LEE VALLEY REGIONAL PARK AUTHORITY

REGENERATION AND PLANNING COMMITTEE

RP/94/25

PLANNING CONSULTATION BY EPPING FOREST DISTRICT COUNCIL

Landscape Strategy Plan summary

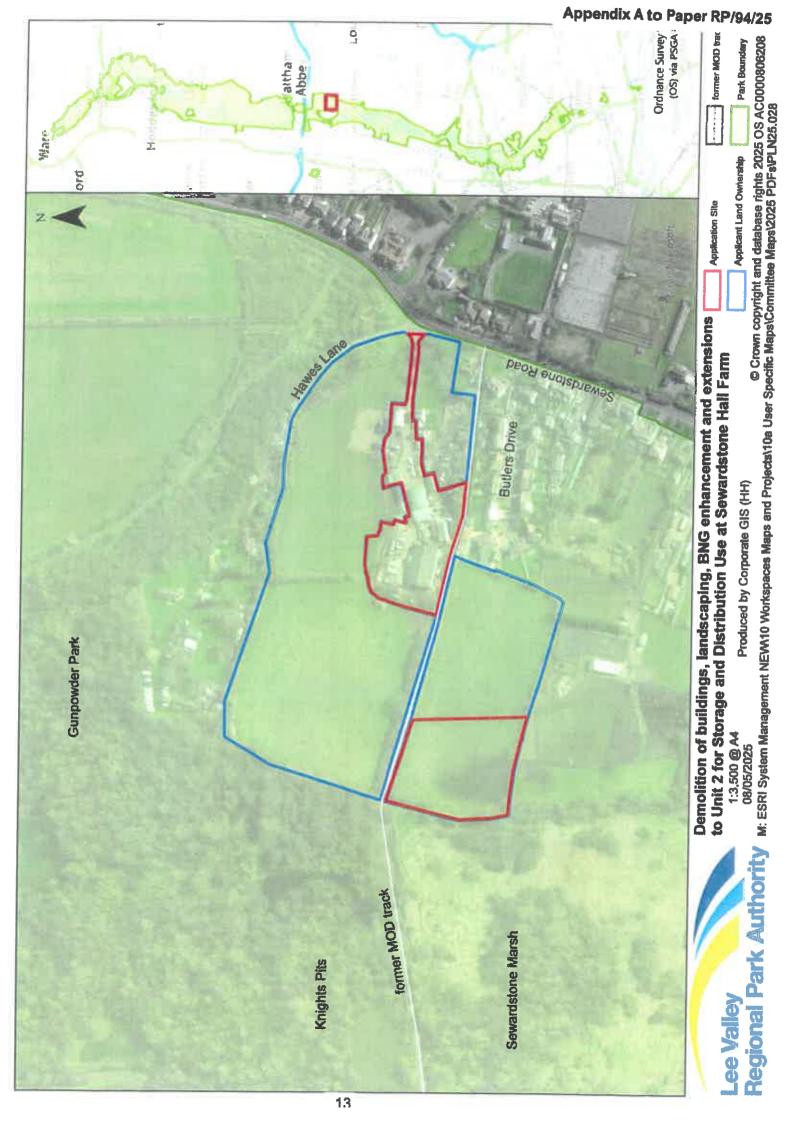
However bat surveys need to be undertaken for some of the buildings that are to be demolished, and a tree on site and this should be provided as part of the application. There are also concerns about whether the proposed landscape plan for the southern boundary, which is shared with an informal access track into the Park, will be able to screen the site as proposed given the space available and the need to secure the site and erect the acoustic fencing; it is noted that a palisade fence secured to concrete blocks and presumed to be a temporary security measure has been erected on site along the same boundary. Therefore, whilst the proposals are considered acceptable in principle a holding objection is required to ensure the required bat surveys can be completed and any required compensation and mitigation considered. A detailed landscape planting plan should also be provided to demonstrate that the southern boundary hedge line can be strengthened to help screen both the site and any boundary fence from the Park.

- Whilst these proposals are welcomed there is concern as to whether there is sufficient space along the southern boundary to achieve a satisfactory buffer to the site as proposed in the Landscape Strategy Plan and in particular whether the existing hedgerow can be strengthened with additional planting sufficient to help screen the site and the proposed acoustic fence. It is also not clear whether the temporary palisade fence that is now on site (and which is not evident in the Landscape Visual Impact Assessment for the site) will remain as a permanent feature or whether the existing lower mesh fencing will be retained. A detailed planting plan should be provided to demonstrate this is achievable and to provide further detail on boundary fencing. This is important because the southern edge to the site also forms the boundary with the permissive access track into the Park, the majority of which has an attractive vegetated edge that links through to Sewardstone Marsh and Knight's Pitts.

- (a) further required bat surveys can be undertaken and completed and consultation on any recommended compensation and mitigation considered;
  - (b) further landscape details can be provided including a planting plan for the southern boundary of the site together with fencing details, to demonstrate that the existing hedgerow can be strengthened and the application site and fence line screened from the adjoining Regional Park.
